NUMBER: 07-001-20 REV. B

Water Pump Inlet Tube Fastener Torque

2018 - 2020 (JL) Jeep Wrangler

Fig. 1
Water Pump Inlet Tube Fasteners

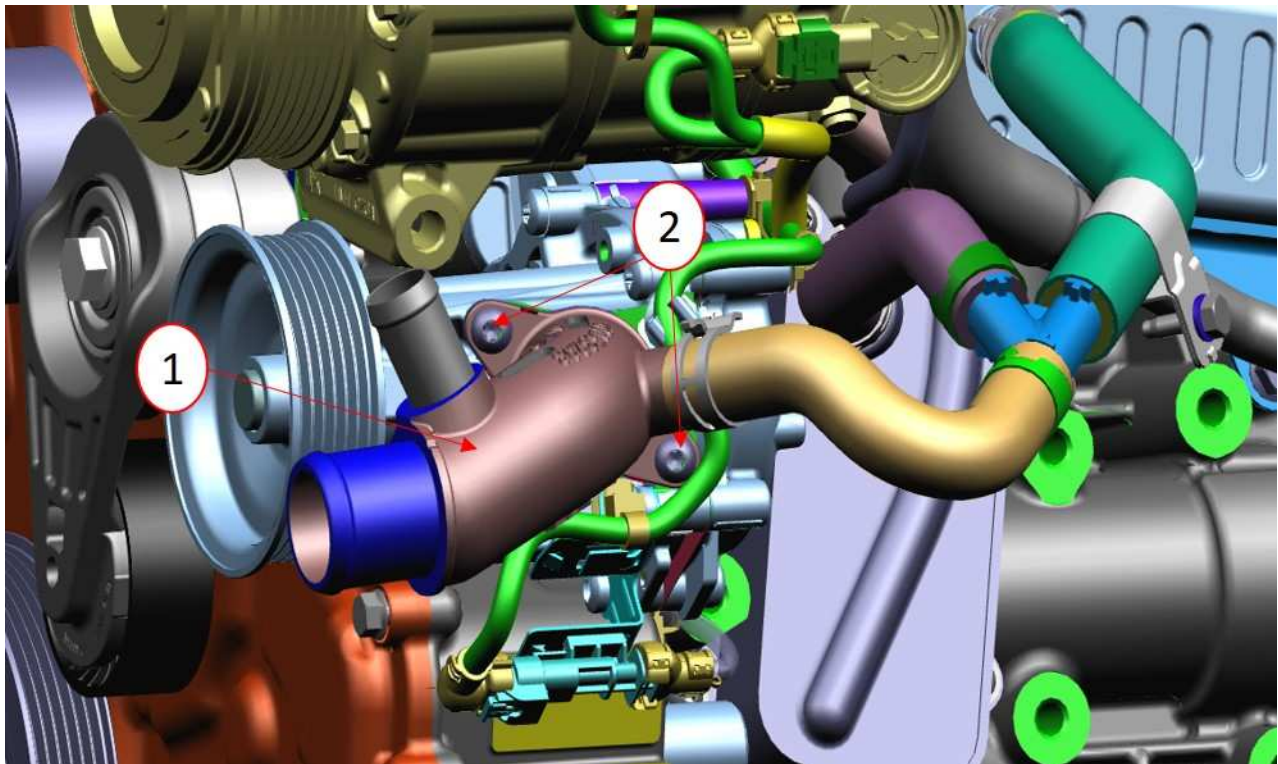
1. Pressure check the coolant system. Refer to the detailed service procedures available in DealerCONNECT> Service Library under: Service Info>07 - Cooling / Diagnosis and Testing >Leak Testing>Pressure Tester Method.
2. Was coolant found to be leaking from the water pump inlet tube at the engine (Fig. 1) ?
 - YES>>> Proceed to [Step 1](#) of the Repair Procedure.
 - NO>>> Coolant was not leaking from this area. This Bulletin does not apply. Normal diagnosis should be performed.

1. Torque the water pump inlet tube fasteners to exactly 11 N·m (97 in. lbs) (Fig. 1) .

2. Pressure check the coolant system. Refer to the detailed service procedures available in DealerCONNECT>Service Library under: Service Info>07 - Cooling / Diagnosis and Testing >Leak Testing>Pressure Tester Method.
3. Is coolant still leaking from the water pump inlet tube at the engine (Fig. 1) ?
 - YES>>> Further diagnosis should be performed.
 - NO>>> This bulletin has been completed.
